2-8-72	
WHITING CORPORATION	
TIDE ROPE REEVEING DIAGRAM	
3 PARTS OF 16 - ROPE No. 1	
DATE 2-17-72	BY WHI
APPROVED H.W.F. DRG	DATE
T-533326

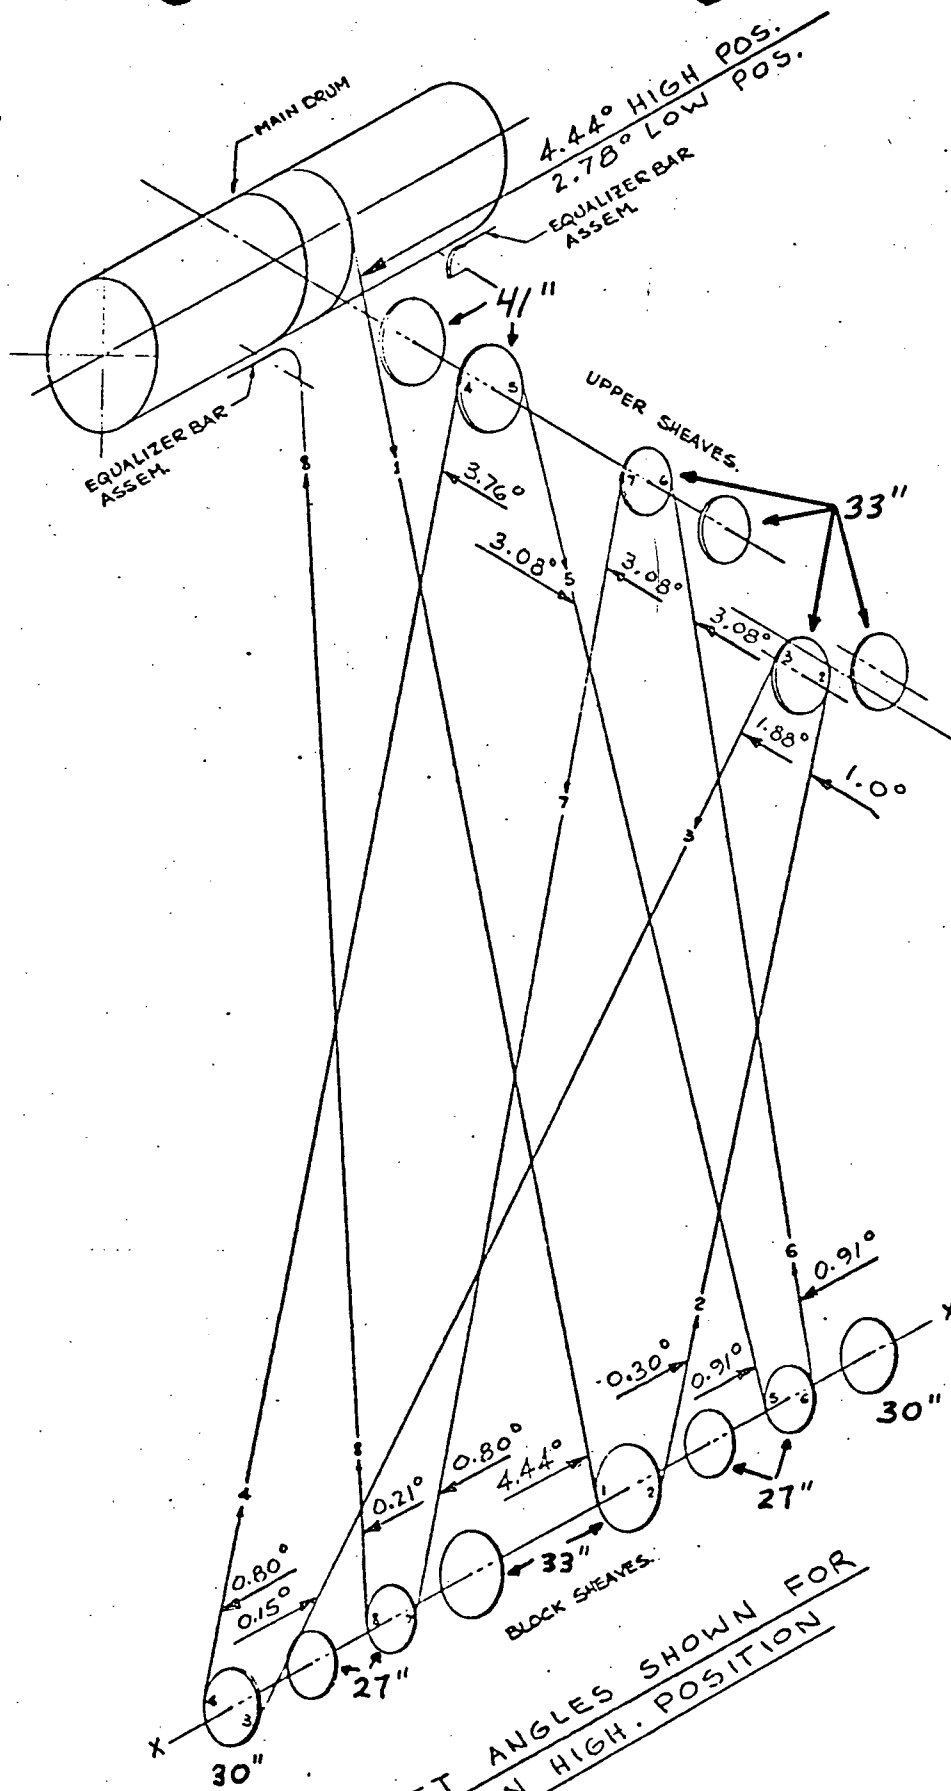
- f. The maximum fleet angle from drum to lead sheave in the load block should not exceed 3 1/2 degrees at any one point during hoisting and should have only one 180° reverse bend for each rope leaving the drum and reversing on the first or lead sheave on the load block with no other reverse bends other than at the equalizer if sheave equalizer is

used. The fleet angles between individual sheaves for rope should not exceed $1\frac{1}{2}$ degrees. Equalizers may be beam or sheave type. For the recommended 6 x 37 IWRC classification wire rope, pitch diameter of lead sheave should be 30 times rope diameter for the 180° reverse bend, 26 times rope diameter for running sheaves, and drum with 13 times rope diameter for equalizers. The pitch diameter is measured from the center of the rope on the drum or sheave groove through the drum or sheave center. The dual reeving system may be a single rope from each end of a drum terminating at a beam type load and rope stretch equalizer with each rope designed for total load, or a two rope system may be used from each drum or separate drums using a sheave equalizer or beam equalizer, or any other combination which provides two separate and complete reeving systems.

CP&L: The maximum fleet angles encountered during the hoisting cycle are illustrated on the attached Whiting Drawing T-53326 which shows rope No. 1. Rope No. 2 has identical fleet angles. These fleet angles are within the ratio of one to 12, or $4^\circ 45'$ which is a Whiting Corporation standard published in 1955 and also appears in Whiting Crane Handbook published in 1967. Minimum fleet angles are necessary to keep wear between the rope and sheave at a minimum. The

4° 45' maximum fleet angle has been established to provide good rope life. Experience with this fleet angle standard on other Whiting cranes at the H. B. Robinson Plant and the Brunswick Unit No. 2 Plant has shown no wear problem. Whiting also reports no problems with this fleet angle standard on their cranes since the 4° 45' requirement was published in 1955.

The only reverse bend in the reeving arrangement is from the main drum to the lead sheave in the load block, however, this reverse bend is not in the category of a reverse bend type addressed in the guide. This is because the distance of the rope between the tangent points on the drum and the sheave is 9' 4". Tangent points must be close coupled on less than two lays of the rope in order for the bend to be considered as a reverse bend. Each lay for the rope is approximately 7". All other rope bends in the reeving arrangement over the load block sheaves and trolley sheaves are direct bend and are not subject to the effects of reverse bending. The trolley sheaves are oriented 90° from the load block sheaves. As the rope passes over one sheave, the greatest strained fiber will be in a neutral axis as it passes over the next sheave oriented 90°. The design of this reeving system has the effect of

increasing the life of the rope. The point of tangency between the load block sheaves and the trolley sheaves is approximately 9' which eliminates any possibility of reverse bends even if the sheaves were oriented to achieve reverse bends.

Sheave diameters are shown on the attached Dwg. T-53326. The sheave diameters meet the minimum requirements of CMAA #70. The sheave diameters are selected to be consistent with experience and to keep the flexing stress from becoming excessive. The trolley and hoisting arrangements are shown on attached Whiting Drawings U-70624, U-70625, U-66666, T-53326 and T-53327.

SECTION B-B' CONTROLLER LAYOUT

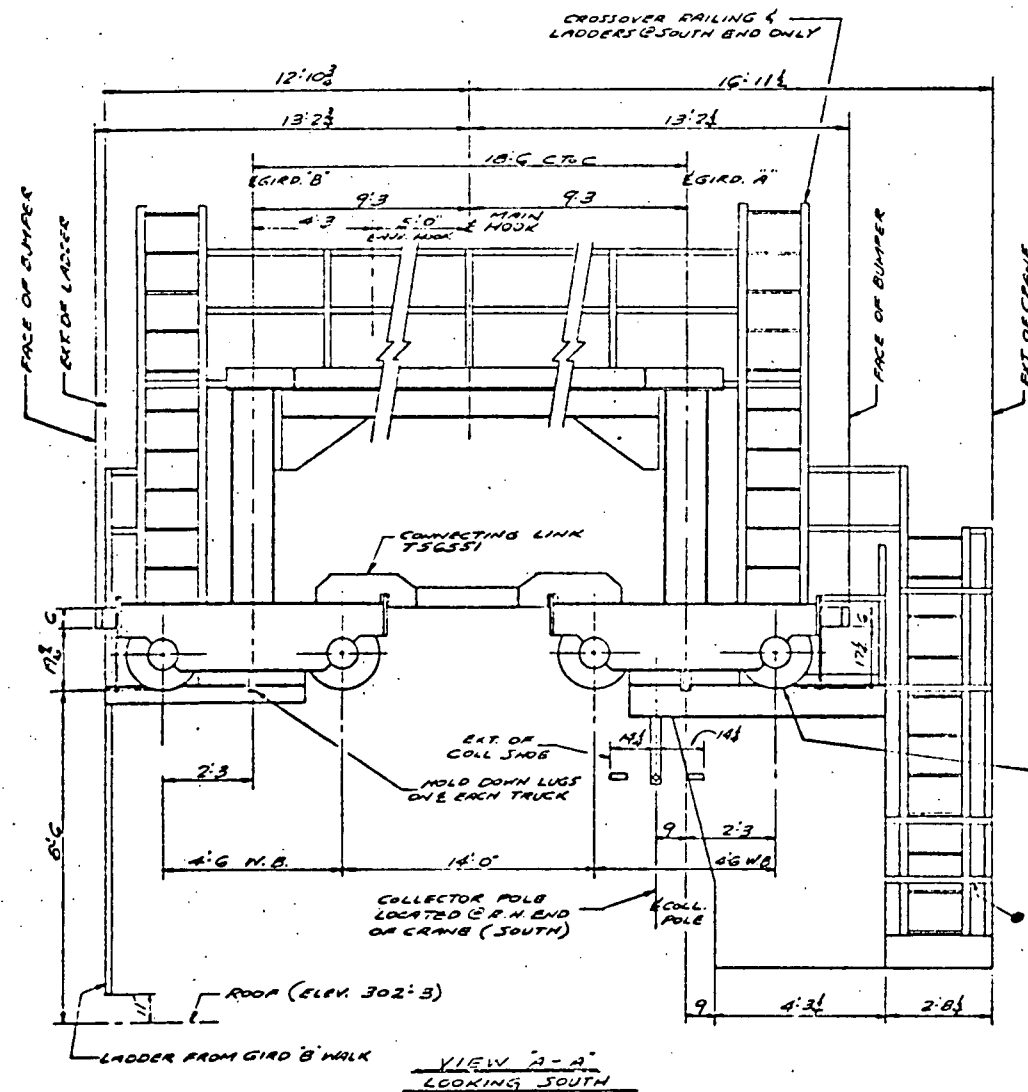
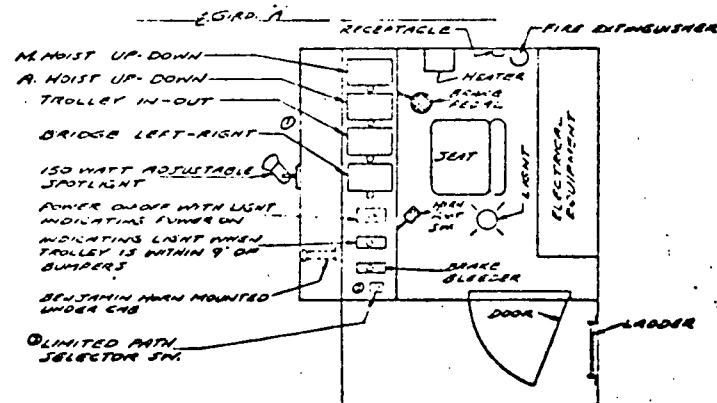
- i. The control systems should be designed as combination electrical and mechanical and may include such items as contractors, relays, resistors, and thyristors in combination with mechanical devices and mechanical braking systems. The electric controls should be selected to provide a maximum breakdown torque limit of 175% of the required rating for a.c. motors or d.c. motors (series or shunt

wound) used for the hoisting drive motor(s). Compound, wound d.c. motors should not be used. The control system(s) provided should consider hoisting (raising and lowering) of all loads, including the maximum design rated load, and the effects of the inertia of the rotating hoisting machinery such as motor armature, shafting and coupling, gear reducer, and drum.

CP&L: The control system for the crane is shown on the attached Whiting Drawing U-71279. The brakes are discussed in Reference (1) of the cover letter. A control to limit the breakdown torque to 175% of the motor rating is unnecessary due to the following:
